SERVICE BULLETIN

MODEL NAME : Di620
MODEL CODE : 1155
NO. : 034
DATE : 990518
SUBJECT : REGULATING PLATE NEWLY MADE

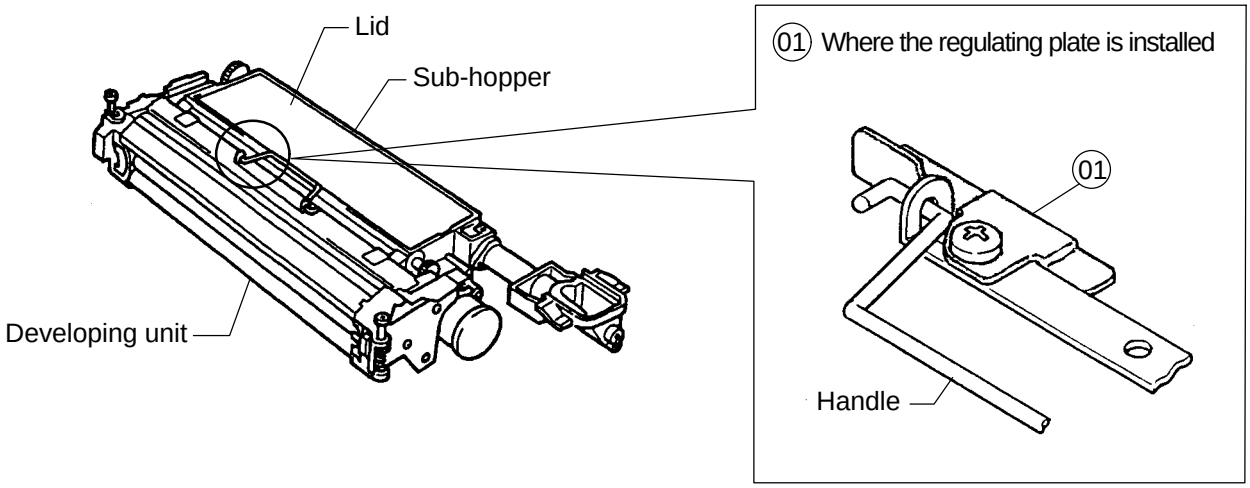
A regulating plate (01) has been newly installed in the position shown below of the developing unit, thereby preventing the handle from lowering toward the sub-hopper side. This has eliminated the possibility of contact between the handle and sub-hopper lid, thus preventing generation of static noise.
